Kinne pump inet pipng options

Subject : Kinne pump inet pipng options 2 attachments**To** : Rusty Sprouse <sprouse@jlab.org>, Michele Solaroli <solaroli@jlab.org>**Cc** : Mathew Wright <mwright@jlab.org>, Thilan Wijeratne <thilan@jlab.org>, Kelly Dixon <kdixon@jlab.org>, Jonathan Creel <creel@jlab.org>

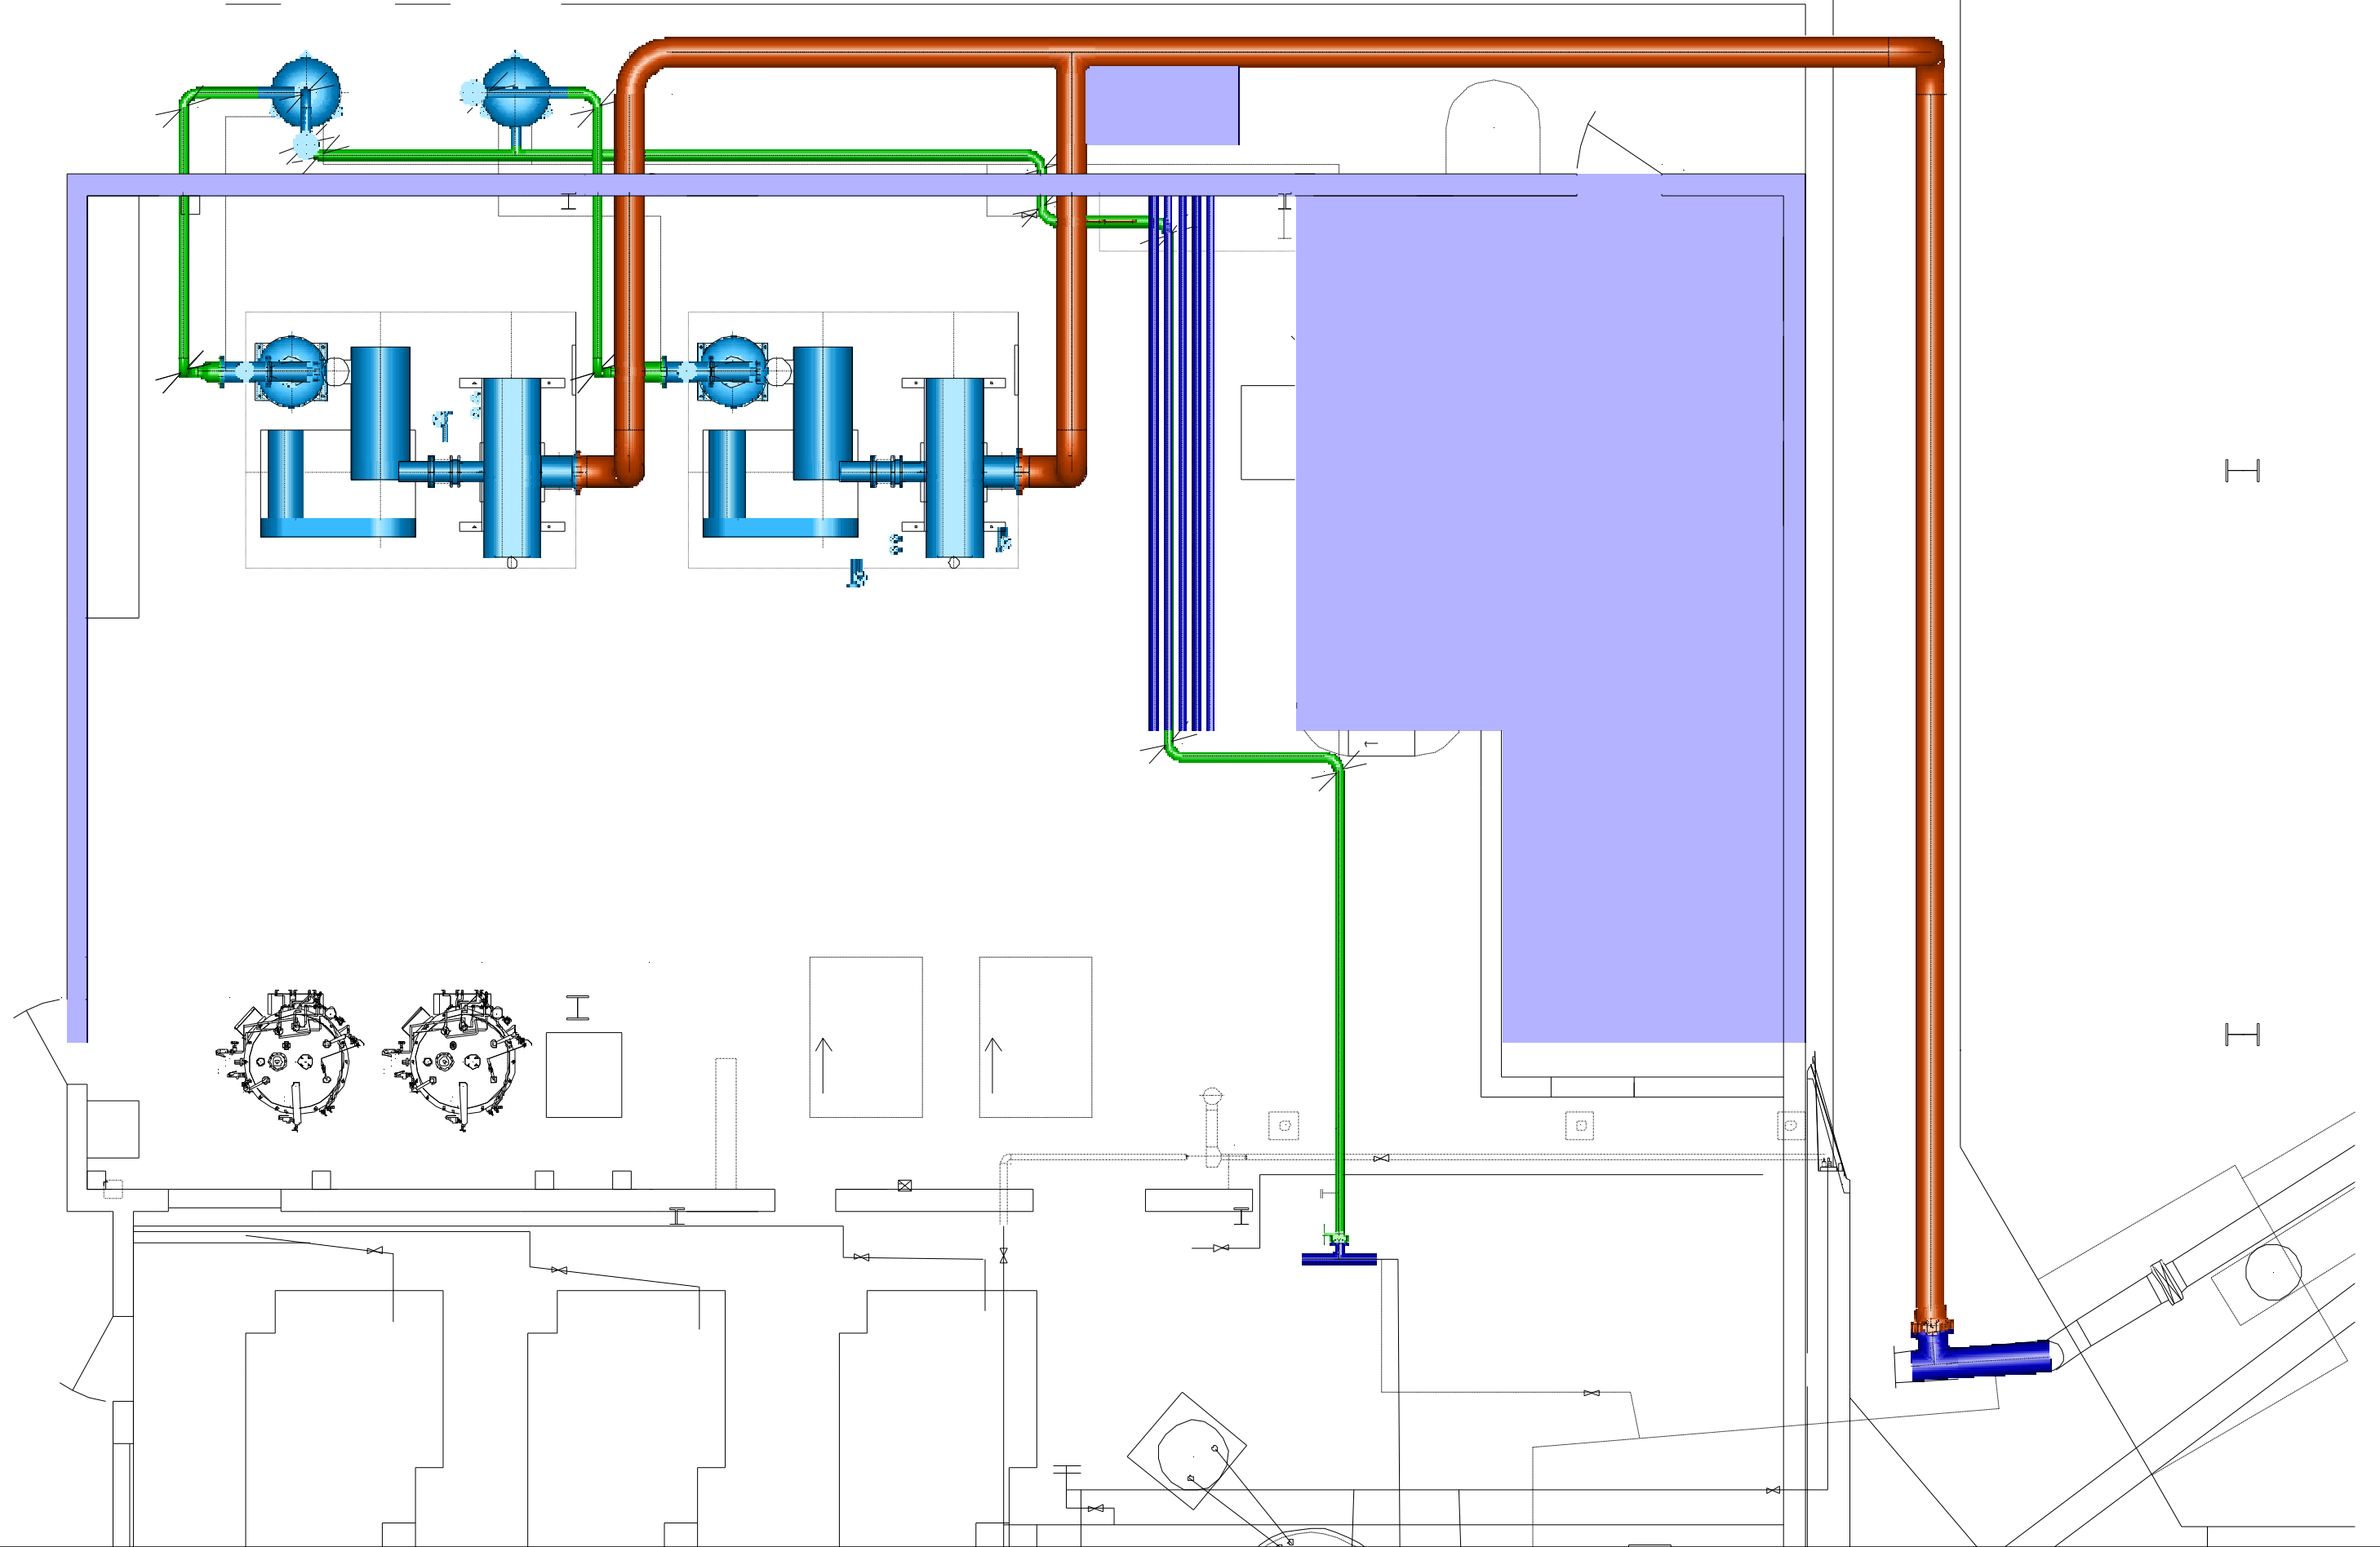
Please find the attached files of the two options to run the 12" NPS Kinney pump suction pipe (the orange color piping is for the outside option and the yellow color piping is for the inside option). The green color piping is the discharge piping and still is in the developmental stage. Please note that these are rough routes. The actual routes may be different than what we present at this moment. We believe that both options will meet the intent of the being able to safely preform maintenance on either of the Kinney pump system.

We suggest running the 12" pipe outside for the follow reasons:

- 1) If piping is running inside, it would take 2-3 weeks more for the design.
- 2) We believe it takes about three more weeks of two techs for installing the piping inside because: a) more pipe fittings are required; b) there will be more effort to lift the piping into place.

Please let us know if we can use the building steel to mount piping support. We also need to know where we can attach rigging in the ceiling if piping is inside.

Mat also mentioned that the work or storing anything is not allowed on the ceiling of the new control room. Could you please advise if we can use the control room to temporary support the piping and people during the construction phase?

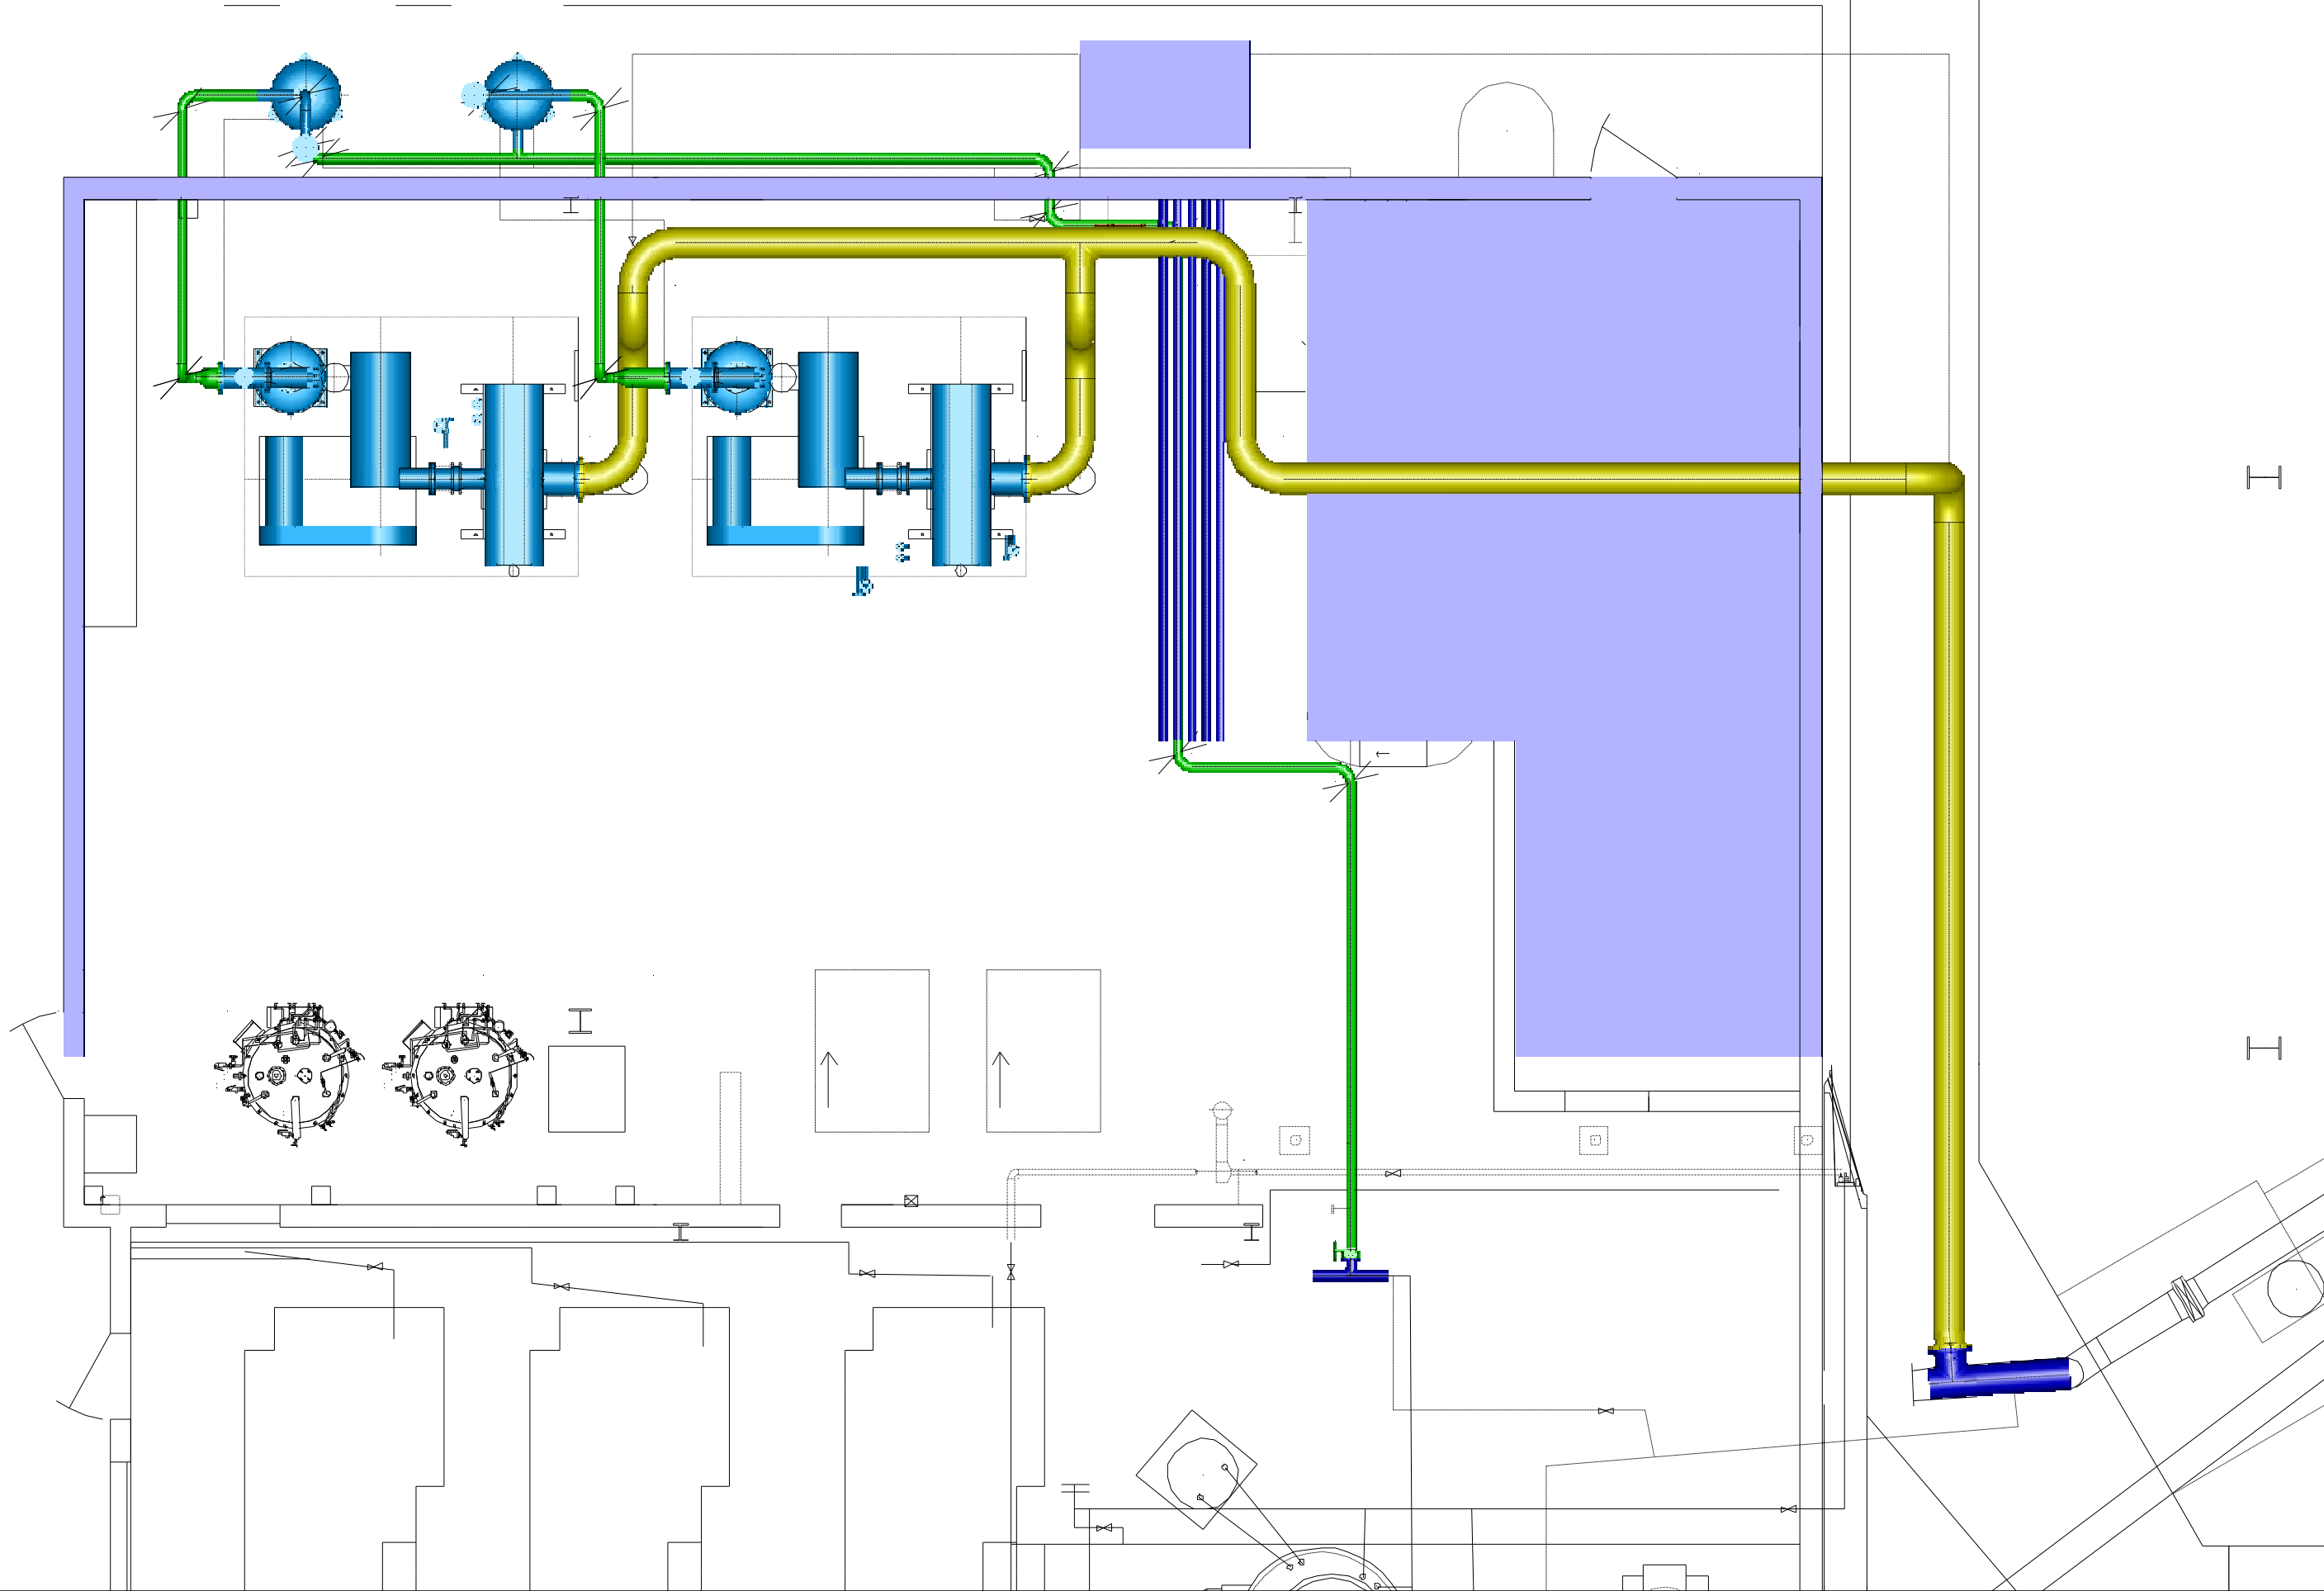
are elevations available?

The elevation views are attached for your information. The height of the piping to the floor is roughly 15 feet for the outside option; it is roughly 18 feet for the inside option.
